SEWAGE DISPOSAL SYSTEM

**HOWARD COUNTY**  
BUREAU OF ENVIRONMENTAL HEALTH  
461-9933

SUBDIVISION Morgan Station ROAD 890 The Old Station Ct LOT 28 ✓

SITE PLAN  
MORGAN STATION  
LOT 28  
PLAT # 7821  
4TH ELECTION DISTRICT HOWARD COUNTY, MD.  
SCALE: 1" = 30' DATE: JUNE 20, 1988

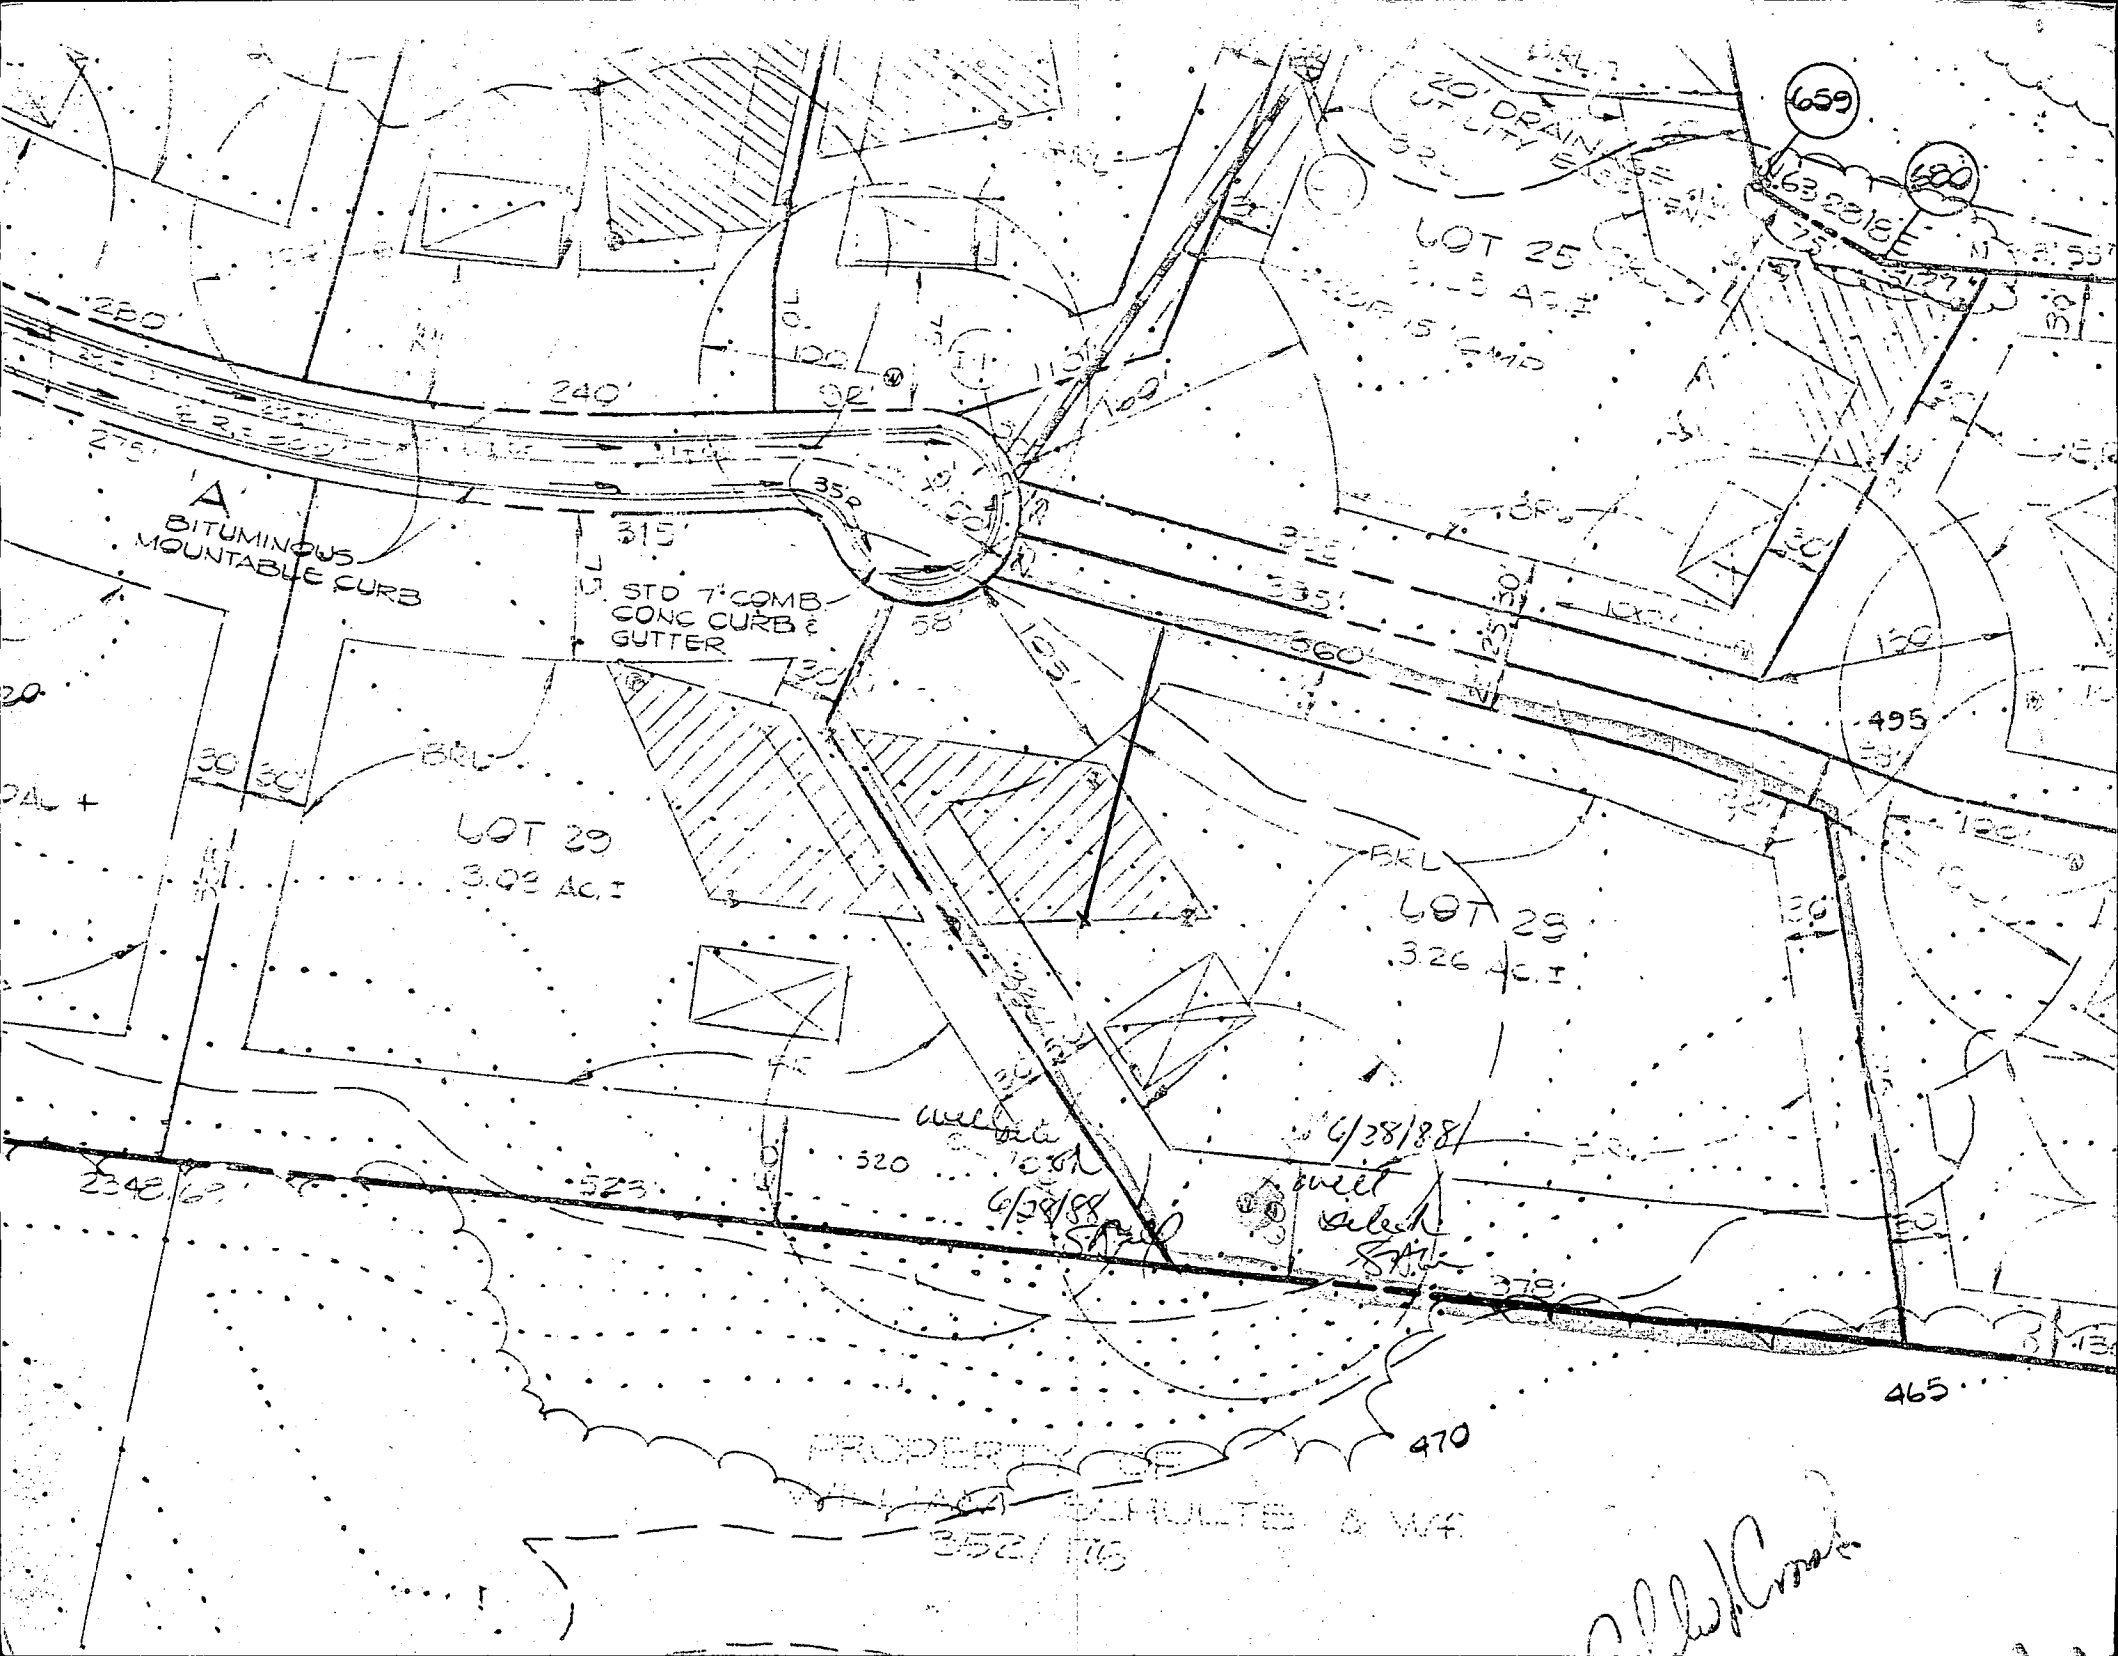
SEPTIC TANK. LEVEL OK CLEANOUTS OK

DISTRIBUTION BOX. LEVEL OK (NEEDS BAFFLE) <sup>OK 9/21</sup>

DRAIN FIELD/TILE FIELD. DEPTH 5 FT. TRENCH WIDTH 3 FT. INLET DEPTH 3 FT.

REMARKS 9/2/88 PERMIT SIGNED - PARTIAL ; OK TO COVER FROM HOUSE  
TO D. BOX ONLY. ; NEED A SEPARATE LINE TO EACH TRENCH FROM D. BOX;  
NEED BAFFLE IN DIST. BOX. <sup>OK 9/21</sup> ; 9/7/88 TRENCH OK FOR STOVE ONLY;  
 LEFT MESSAGE AT MACHINE ON PAPER; PARTIAL CARD 9/21/88  
OK TO COVER - FILE, C.B.O.

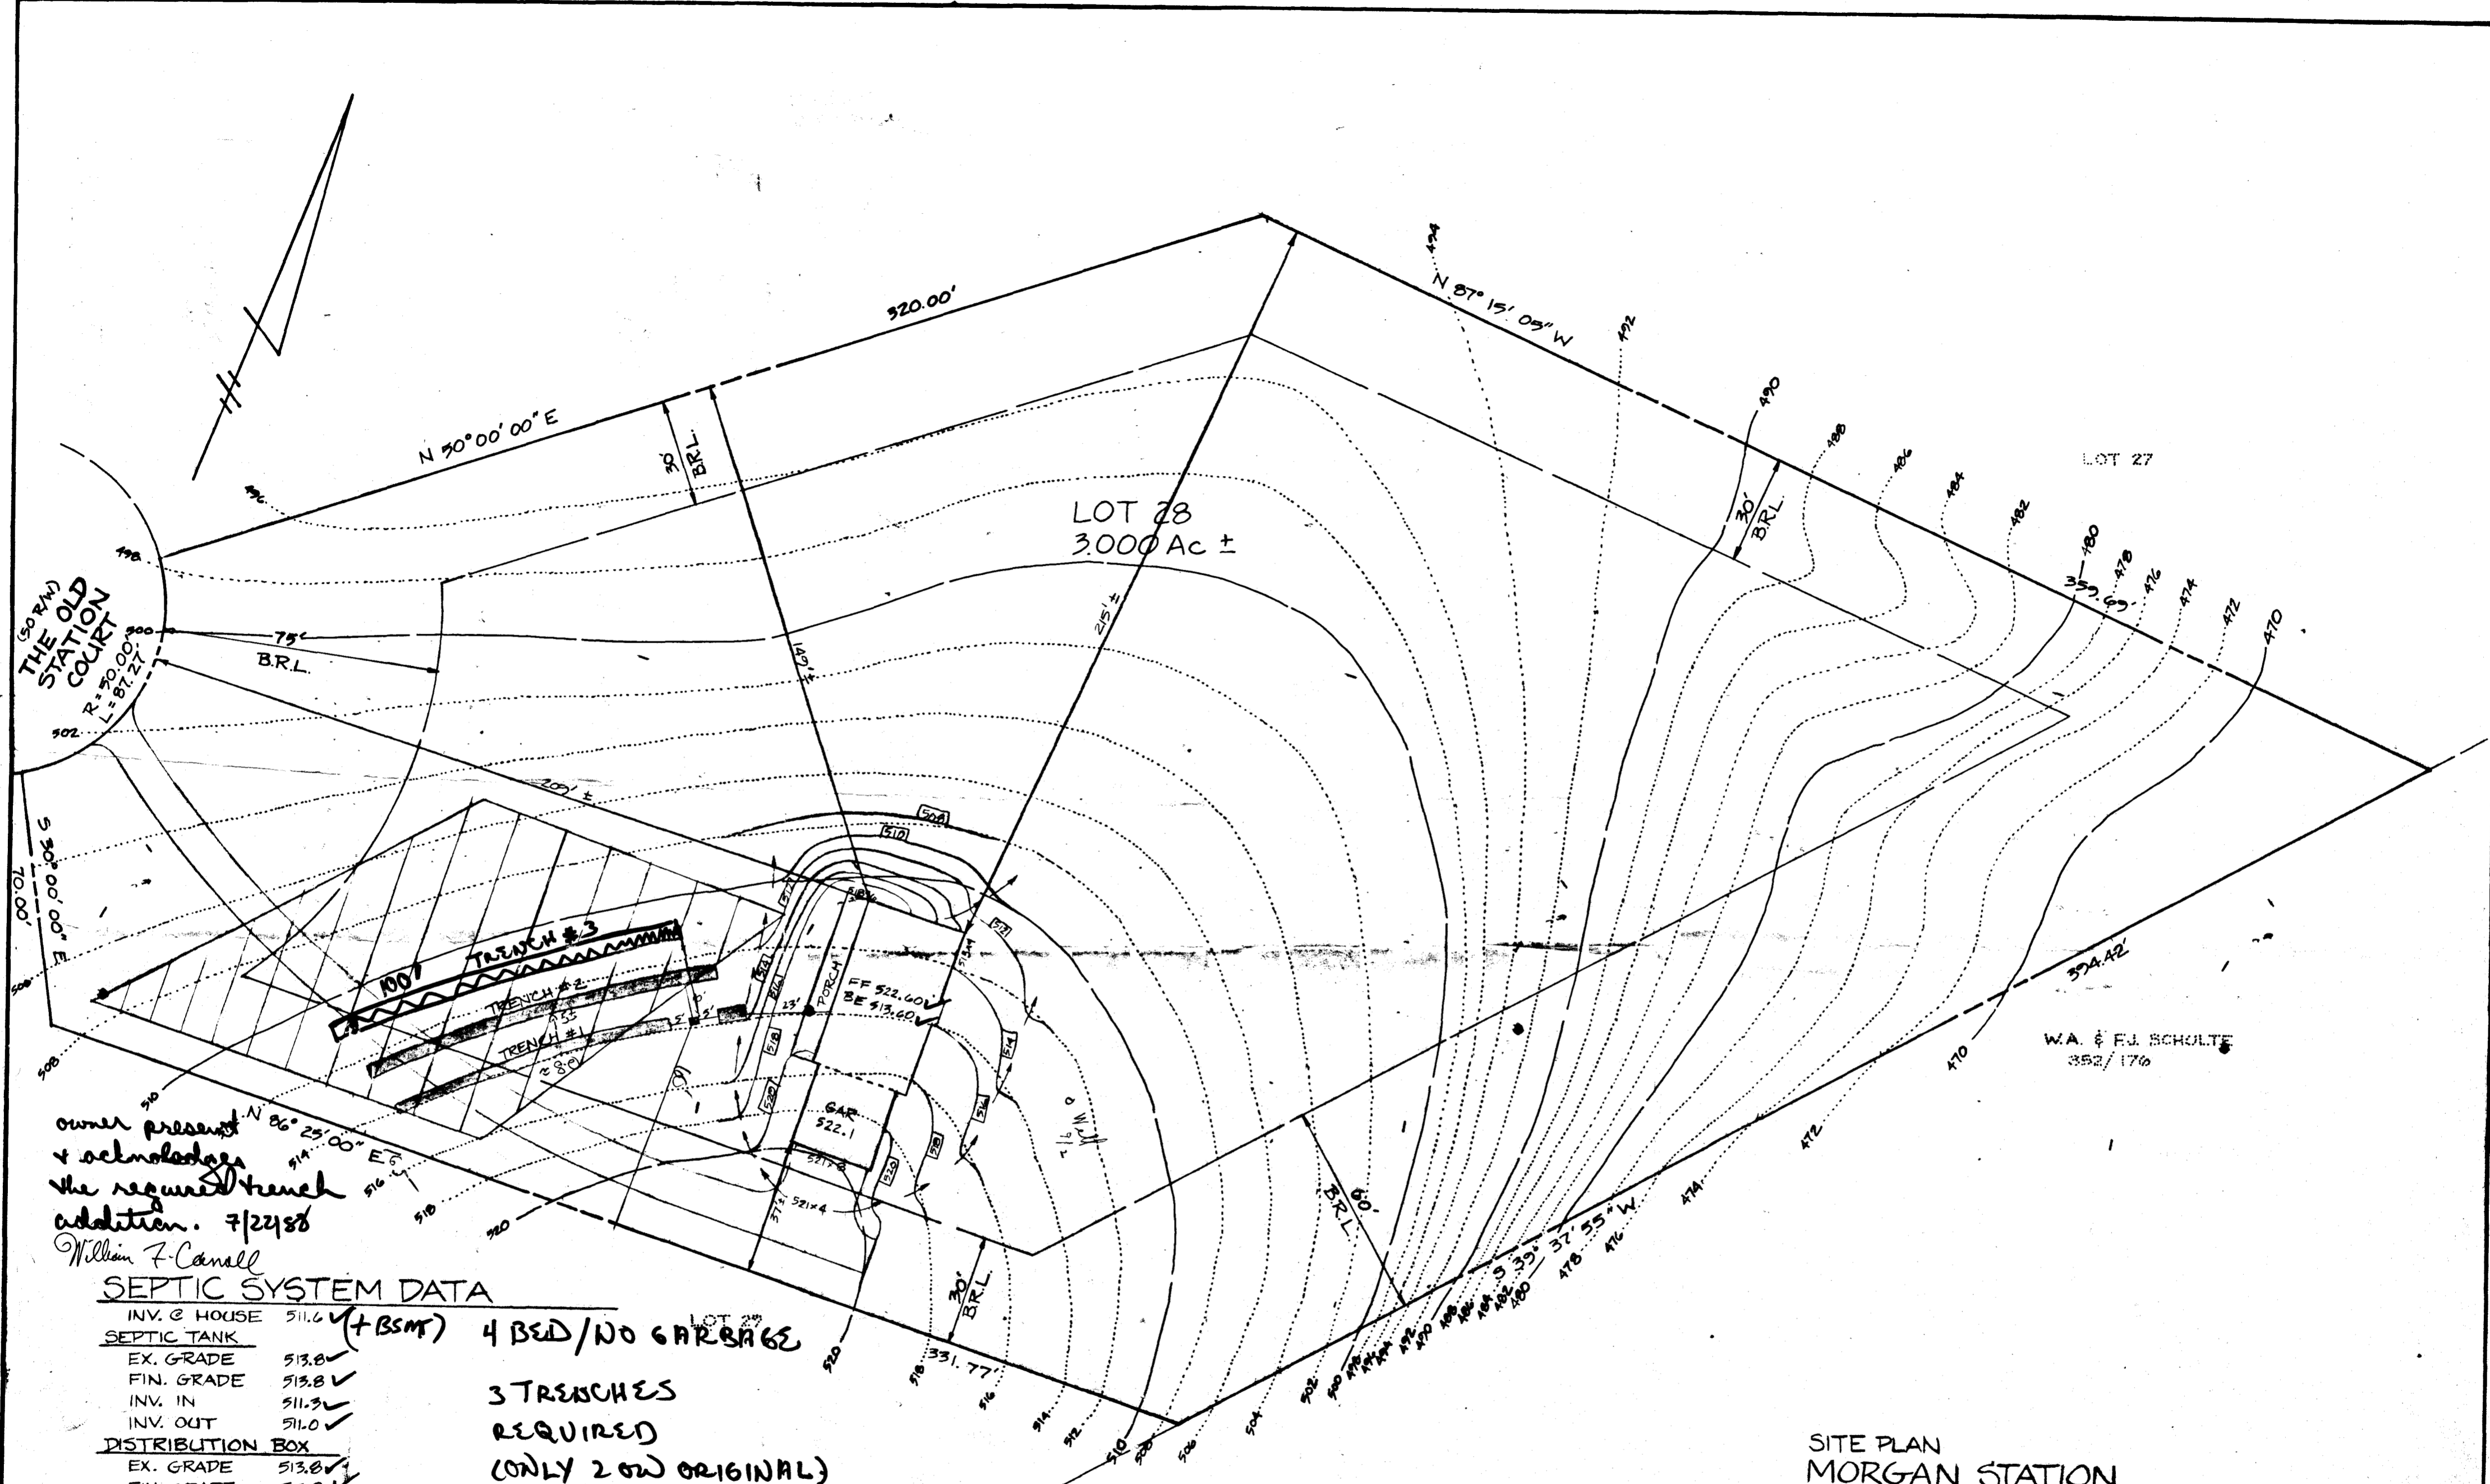
owner present  
& acknowledges  
the required trench  
addition. 7/22/88  
William F. Canall

3 TRENCHES  
REQUIRED  
(ONLY 2 @ ORIGINAL)

7/7/88  
elevations ok  
SAC
